Chesterton High School

Section A8

DURO-LAST, INC.
525 MORLEY DRIVE
SAGINAW, MICHIGAN 48601

CHESTERTON HIGH SCHOOL
SECTION A8
WR KELSO

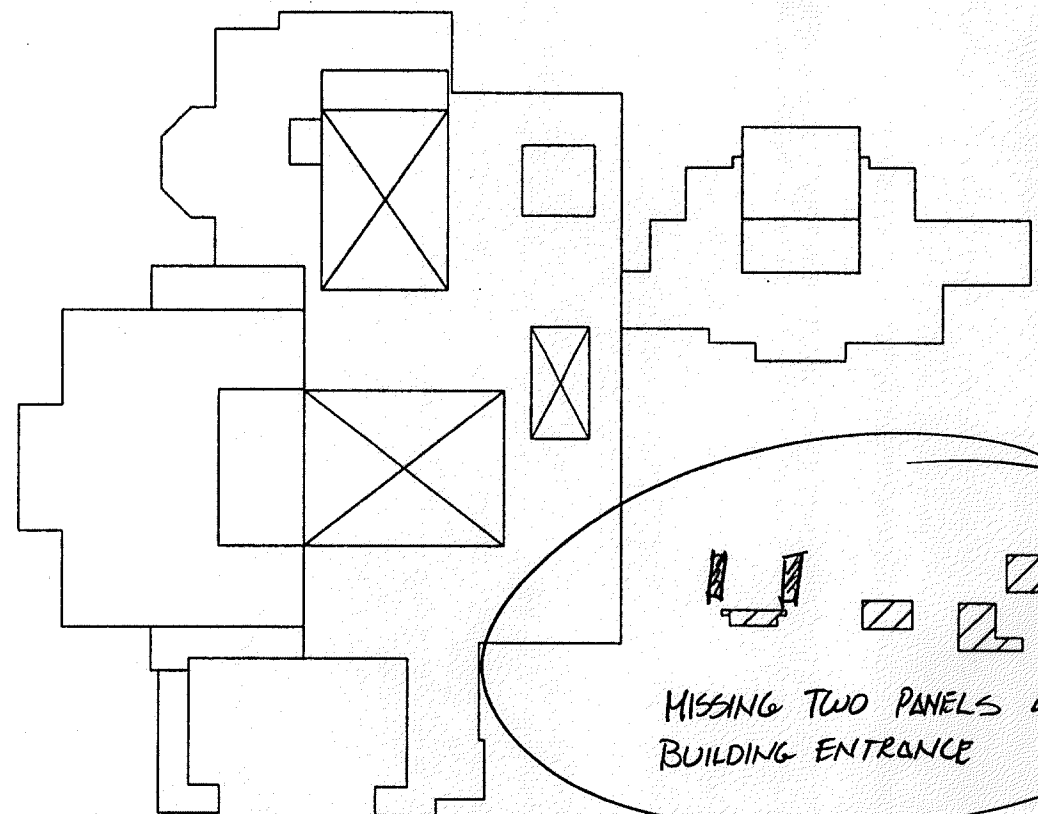
MISSING TWO PANELS AT BUILDING ENTRANCE
